STAFF REPORT

PLANNING & ZONING COMMISSION

1. CERTIFICATE OF APPROPRIATENESS REVIEW

Applicant: Matthew Althouse
Location: 26 W Olentangy Street
Existing Zoning: Downtown Business District (DB)
Request: To review a proposal to renovate an existing building for the purposes of a restaurant, and approve a parking plan for the proposal, as allowed by Section 1143.16 (g) (7) of the Powell Zoning Code.

Exhibit 2.3: Mixed Use Village Center Detail

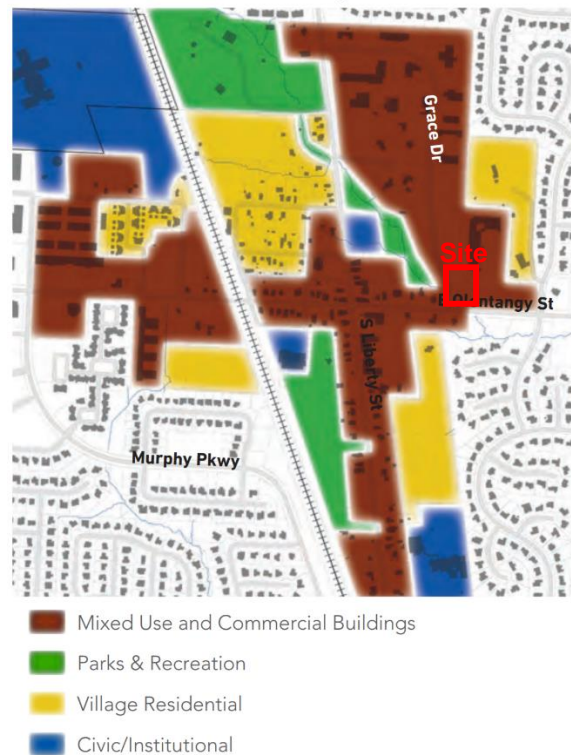
The Land Use Plan portion of the Comprehensive Plan, specifically the Village Residential portion that this site is located within (see image below) states that (p. 30):

"If sensitively designed to fit with the scale and unique character of existing downtown development, a variety of housing options could be appropriate and beneficial in advancing the economic vibrancy, character, and livability of Downtown Powell."

Staff feels that the proposed architecture is very nice and could be an added benefit to the community. However, the location of housing along Grace Drive may not be the best place for it. A major thoroughfare, it sees a fair amount of traffic and having homes so close to it may be uncomfortable for anyone living in the homes. Also, this organization of buildings so close together to the road does not seem to fit within Powell's downtown esthetic. It feels more suburban than historic.

Furthermore, Land Use policy #6 (p. 49) recommends encouraging mixed use development in appropriate locations, as designated in the plan. This policy states that "in particular, large residential development sites with arterial roadway frontage should preserve that frontage for commercial uses that will both generate revenue for the City, while also providing jobs and services within walking distance of nearby homes." This proposal is contrary to this policy recommendation.

Staff recommends that the application resubmit a new sketch with the following changes:

1. Redesign the site plan to include more commercial.
